SUNDRY NOTICES AND REPORTS ON WELLS

8. Well Name and No.
Sand Tank 10 Fed 1

EOG Resources proposes to P&A this well as follows:
RIH Verify ABTD @ 6755

Permanent Abandonment of Federal Wells
Conditions of Approval

CURRENT WBD

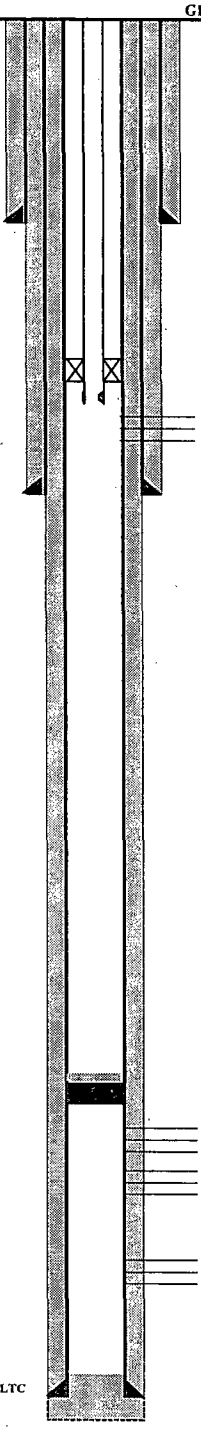
"Sect. Potash"
note: all plugs

1. Spot ~~20~~ sx Class C cement plug at 4200'. 25 sx min. 40' min 25 sx min.
2. Spot 60 sx Class C cement plug at 3334'. WOC minimum 4 hrs. 130' min
3. Tag plug at or above 3234'.
4. Spot ~~20~~ sx Class C cement plug at 3035'. 25 sx min 130' min
5. Spot ~~20~~ sx Class C cement plug at ~~1200'~~. 25 sx min 1390 - 1290 WOC Tag
6. Spot 55 sx Class C cement plug at 440'. WOC minimum 4 hrs. 500 - 340
7. Tag plug at or above 340'.
8. Spot 15 sx Class C cement from 100' to surface. Add cement as needed to fill casing to surface.
9. Cut wellhead and weld on P&A marker. Clean and restore location.

5. Cement Requirement: Sufficient cement shall be used to bring any required plug to the specified depth and length. Any given cement volumes on the proposed plugging procedure are merely estimates and are not final. Unless specific approval is received, no plug except the surface plug shall be less than 25 sacks of cement. Any plug that requires a tag will have a minimum WOC time of 4 hours.
